Designation: ~~C617-10~~ Designation: C617/C617M - 11

Standard Practice for Capping Cylindrical Concrete Specimens¹

FIG. 1 Sketch of Cover Plate for 2-in. (50-mm) [2-in.] Cube Mold

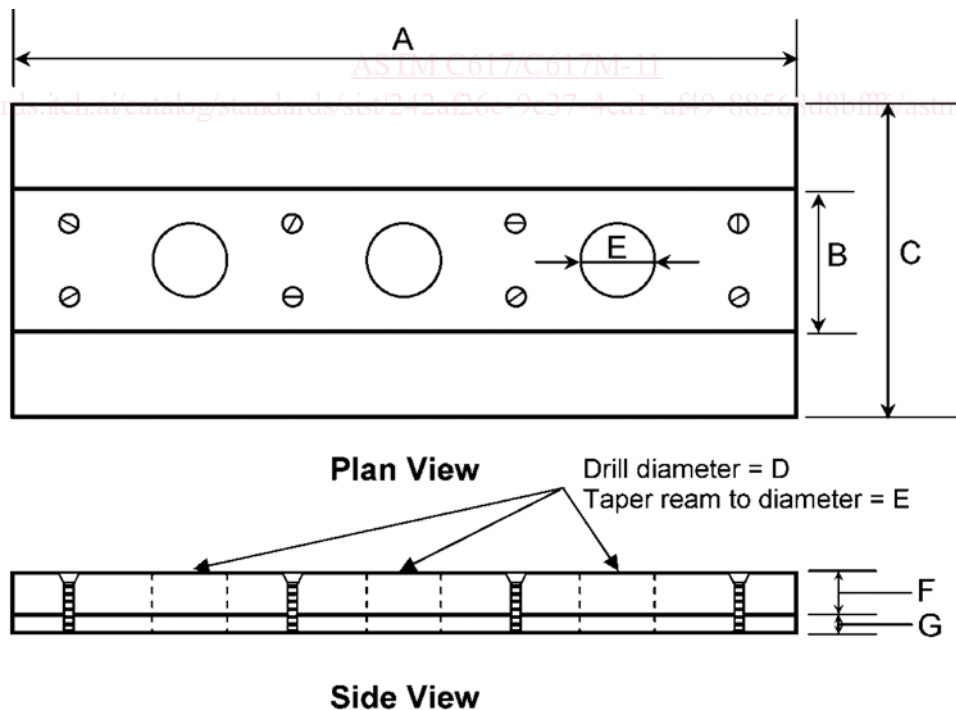
5.4.2 Determination of Compressive Strength—Prepare test specimens using a cube mold and base plate conforming to the requirements of Test Method C109/C109M and a metal cover plate conforming in principle to the design shown in Fig. 1 (Note 7). Bring the various parts of the apparatus to a temperature of 68 to 86 °F (20 to 30 °C), lightly coat the surfaces that will be in contact with the sulfur mortar with mineral oil, and assemble near the melting pot. Bring the temperature of the molten-sulfur mortar in the pot within a range of 265 to 290 °F (129 to 143 °C), stir thoroughly, and begin casting cubes. Using a ladle, or other suitable pouring device, quickly fill each of the three compartments until the molten material reaches the top of the filling hole. Allow sufficient time for maximum shrinkage, due to cooling, and solidification to occur (approximately 15 min) and refill each hole with molten material (Note 8). Bring the various parts of the apparatus to a temperature of 20 to 30 °C [68 to 86 °F], lightly coat the surfaces that will be in contact with the sulfur mortar with mineral oil, and assemble near the melting pot. Bring the temperature of the molten-sulfur mortar in the pot within a range of 129 to 143 °C [265 to 290 °F], stir thoroughly, and begin casting cubes. Using a ladle, or other suitable pouring device, quickly fill each of the three compartments until the molten material reaches the top of the filling hole. Allow sufficient time for maximum shrinkage, due to cooling, and solidification to occur (approximately 15 min) and refill each hole with molten material (Note 9). After solidification is complete, remove the cubes from the mold without breaking off the knob formed by the filling hole in the cover plate. Remove oil, sharp edges, and fins from the cubes and check the planeness of the bearing surfaces in the manner described in Test Method C109/C109M. After storage at room temperature to the desired age, but not less than 2 h, test cubes in compression following the procedure described in Test Method C109/C109M, and calculate the compressive strength.

Label	A	B	C	D	E	F	G
Dimension, mm [in.]	255 [10]	45 [1¾]	100 [4]	22 [7/8]	24 [1½/16]	12 [½]	6 [¼]
